CITY OF ALBUQUERQUE

RE: Starbucks at 4601 Wyoming Blvd NE
Grading and Drainage Plan
Engineer's Stamp Date 1-9-2017 (File: F19D013C)

Based upon the information provided in your submittal received 1-9-2017, the above referenced Grading and Drainage Plan cannot be approved for building permit until the following comments are addressed:

SHEET TITLE:
DRAINAGE AND UTILITY PLAN
SCALE: AS SHOWN

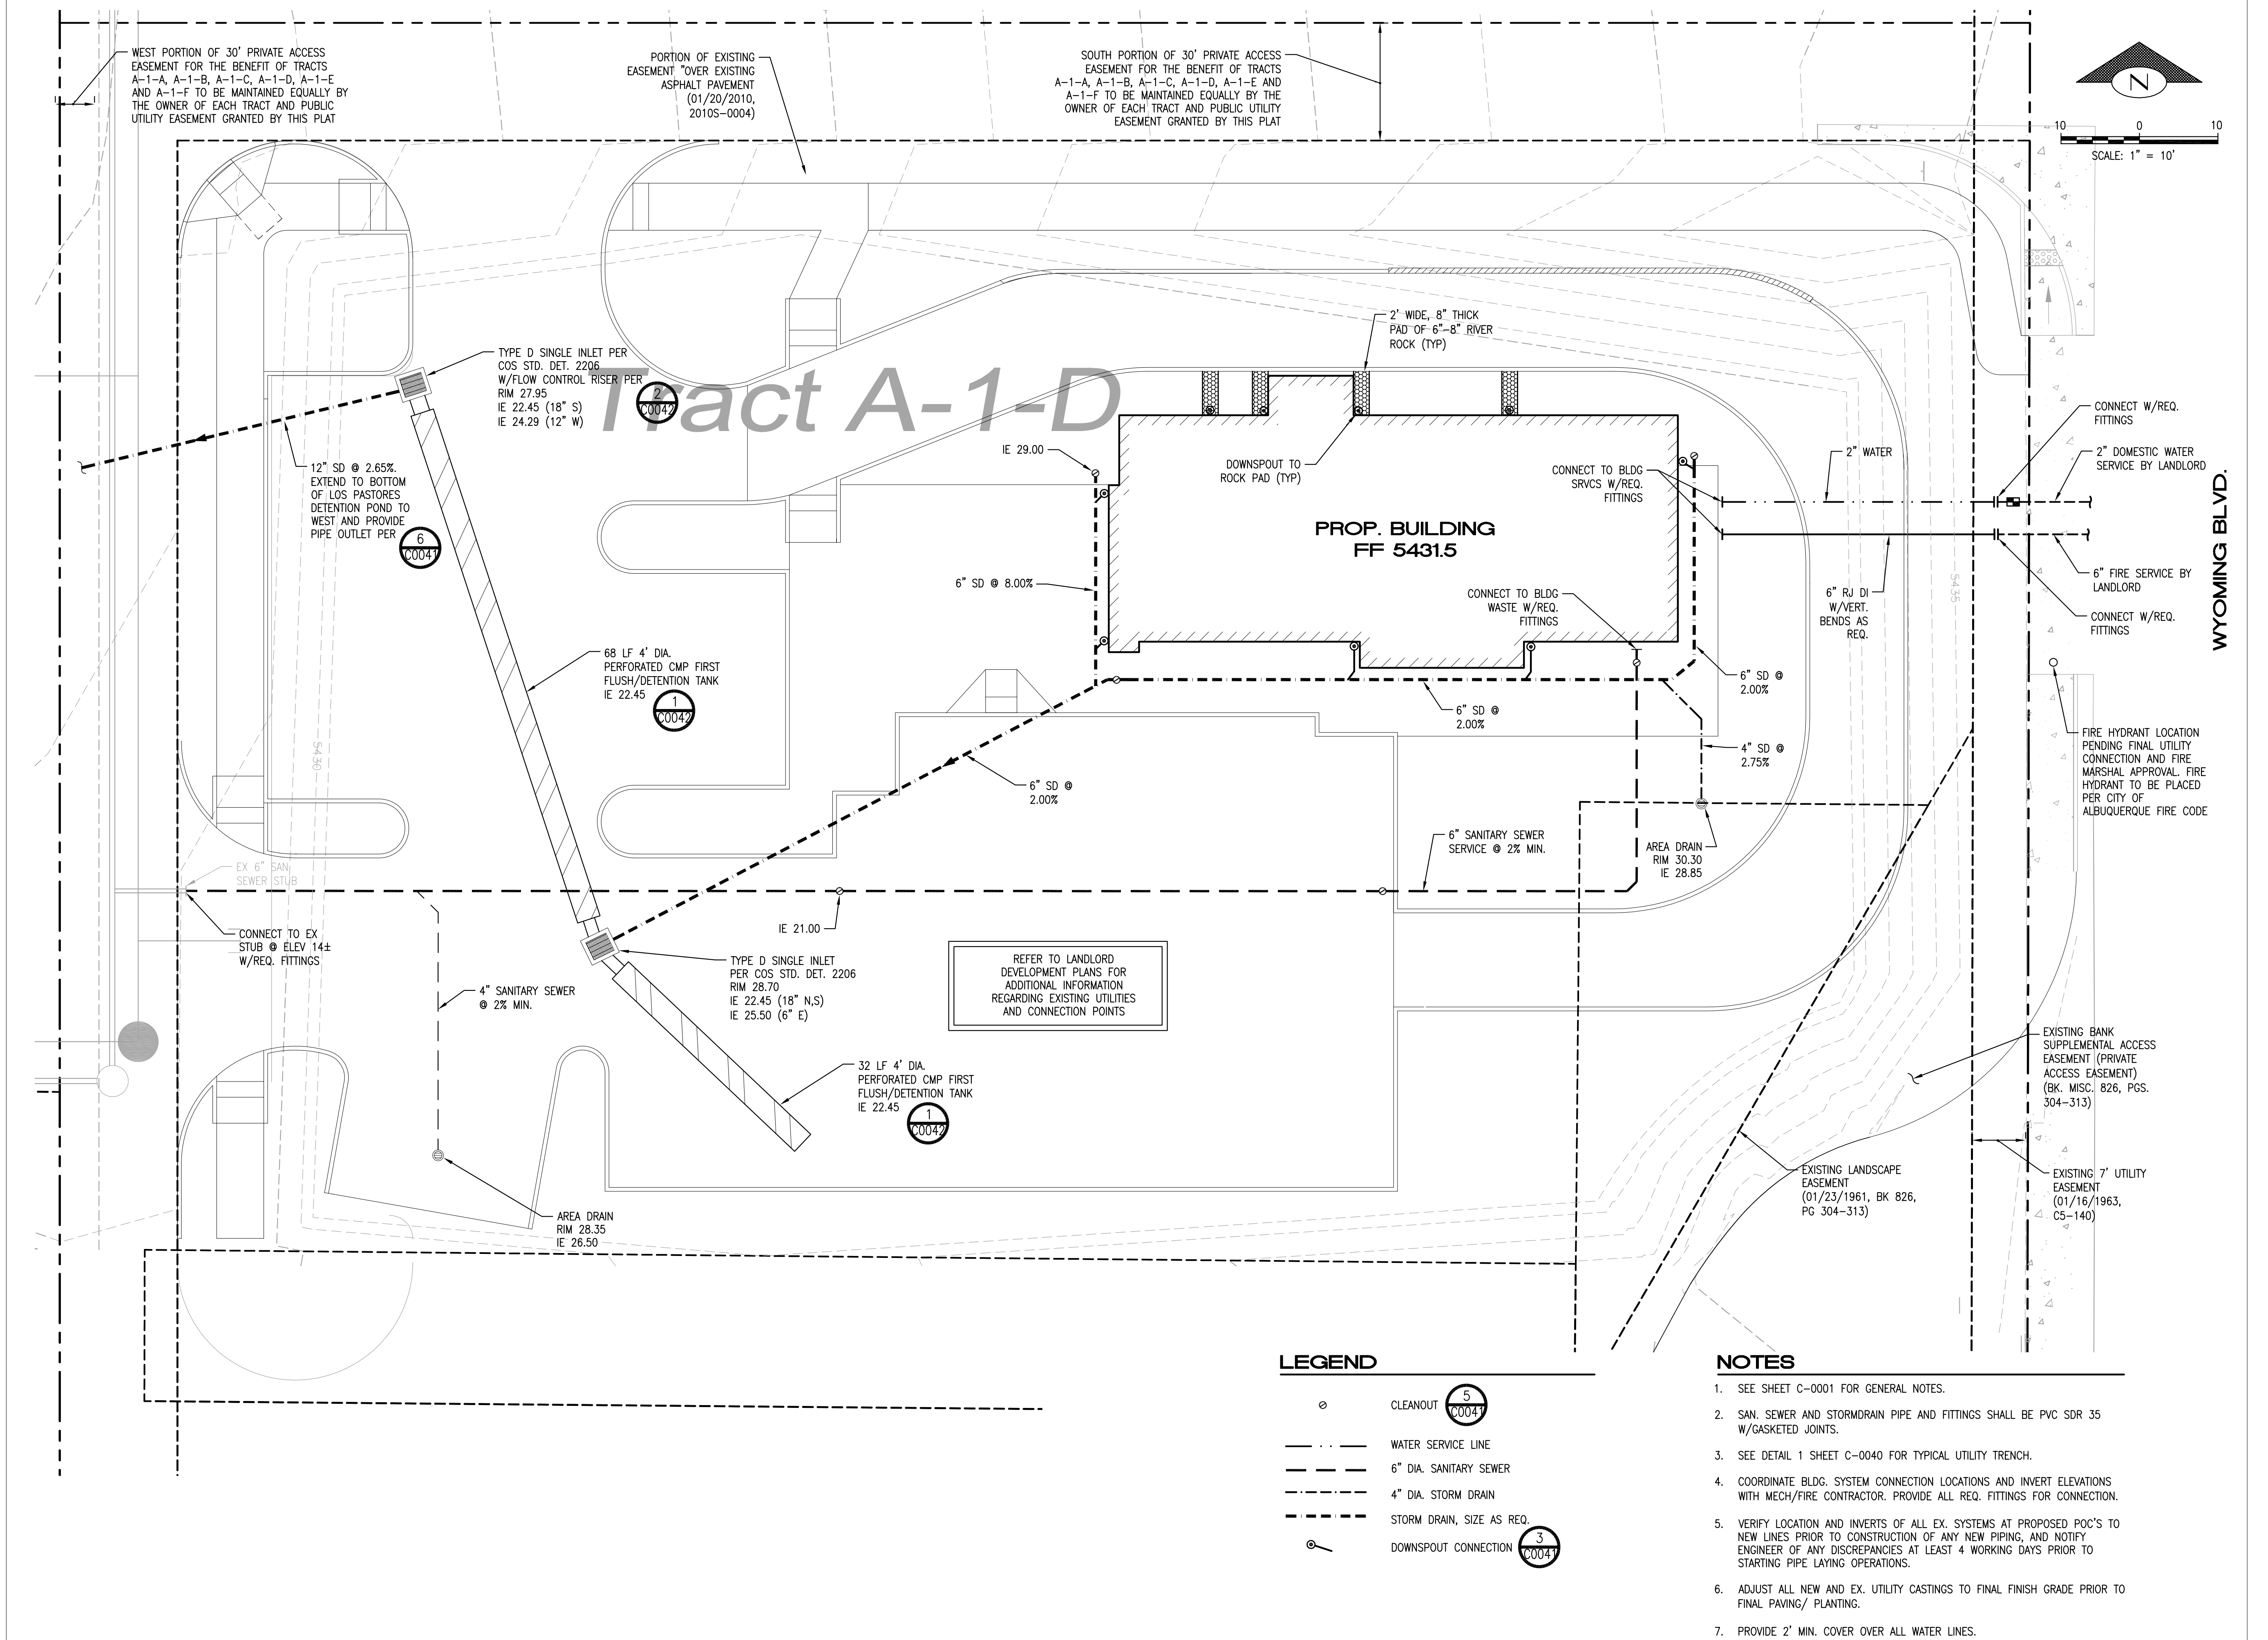
1. We recommend to use COA modified grate detail (see attached) include a copy with this plan with your next submittal.
2. Show the entire stretch of the 12 inches storm drain to the pond including grades, inverts and other utility crossing. Provide easement document across the adjacent property. Who will maintain the pond?
3. Clearly show the property line with boundary information.
4. Trash enclosure drain must drain to a grease trap then to SAS.
5. Please fix spelling of "COS STD" to "COA STD".
6. Sheet C 0001 was not printed.
7. Erosion and sediment control plan must be approved prior to building permit approval.
8. Provide inverts for the 4 feet Dia. CMP.
